**BLOOMINGTON PLAN COMMISSION
STAFF REPORT
Location: 335 W. 8th Street**

**CASE #: SP-27-21
DATE: October 18, 2021**

Date: October 18, 2021
To: Bloomington Plan Commission
From: Bloomington Environmental Commission
Subject: SP-27-21: Johnson Creamery Apartments
335 W. 8th Street

EAST ELEVATION

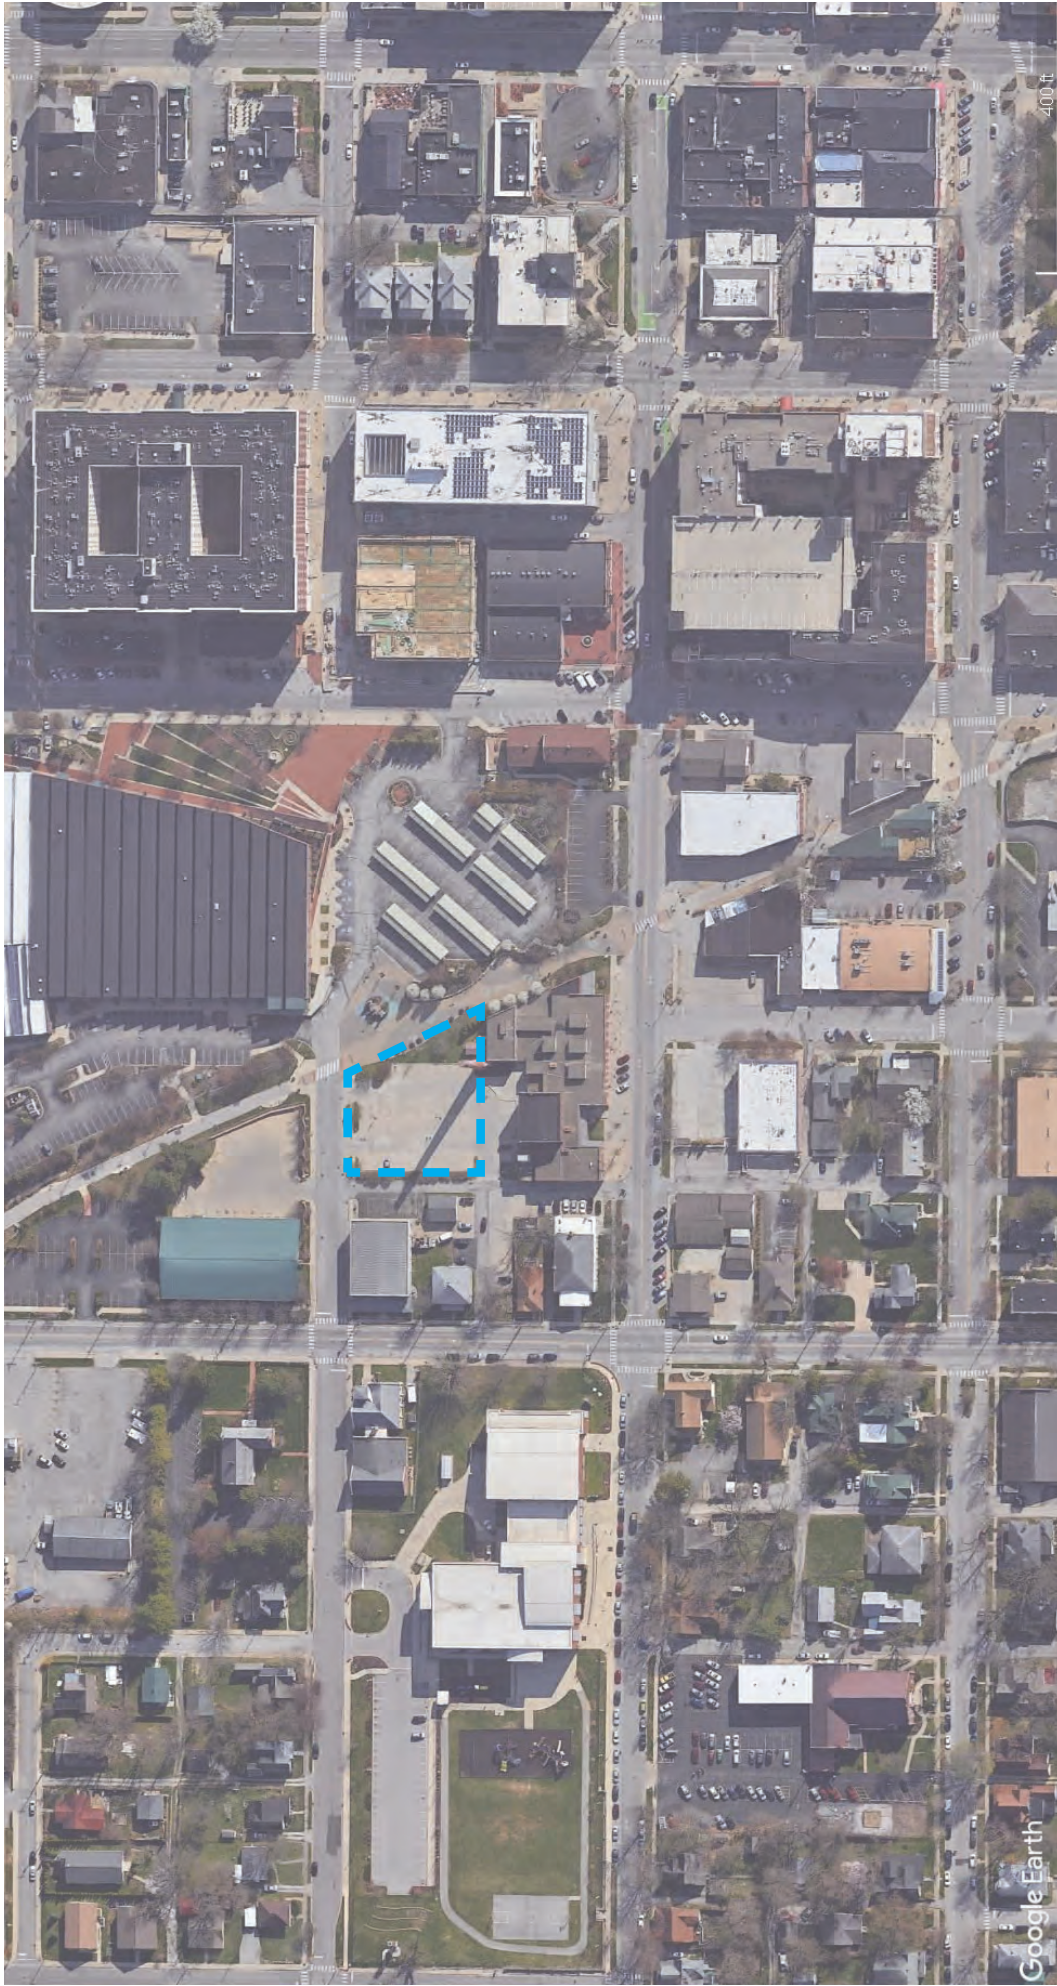
Void-to-Solid Percentage: The DCO sets a minimum first floor void-to-solid requirement of 60%, consisting of transparent glass or façade openings, for facades facing a street or the B-Line. The proposed building facades along both of these frontages meet this requirement with 85% void-to-solid shown along the 8th Street frontage and 60% shown along the B-Line Trail frontage.

PLANTING PLAN

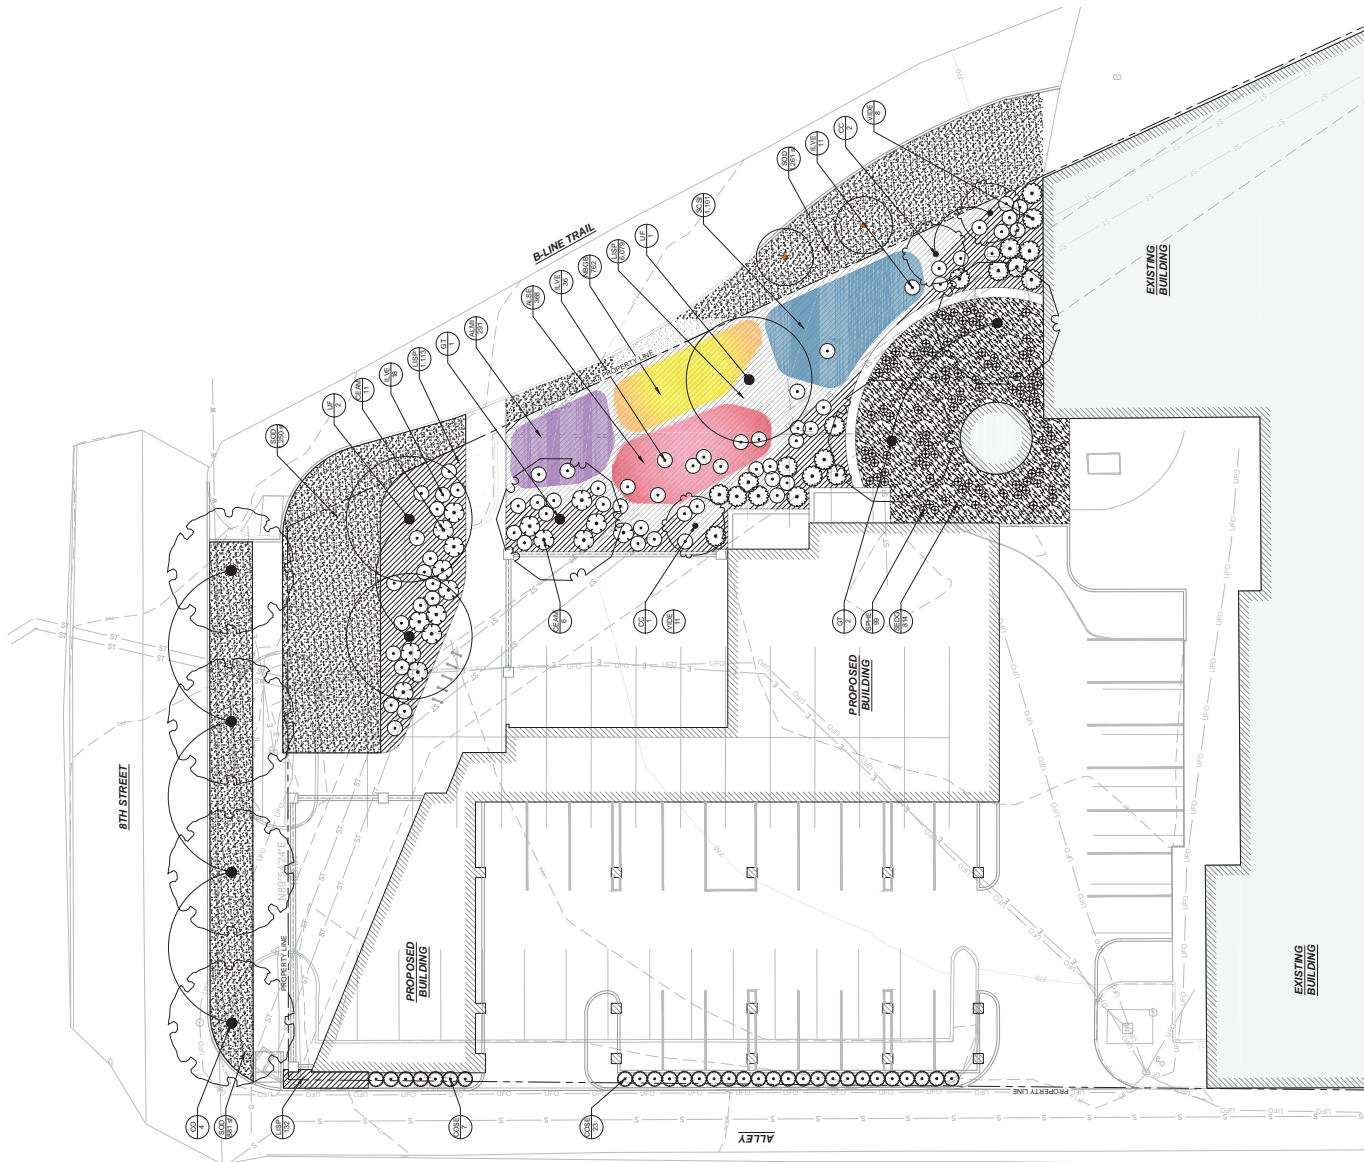
The Landscape Plan needs to be finalized with the grading permit. Some plant species will need to be changed (example is *Ulmus* x 'Frontier'), and the amount of pervious surface needs to be calculated to determine the quantity of interior plants.

1.) Revise the Landscape Plan prior to the Grading Permit issuance.
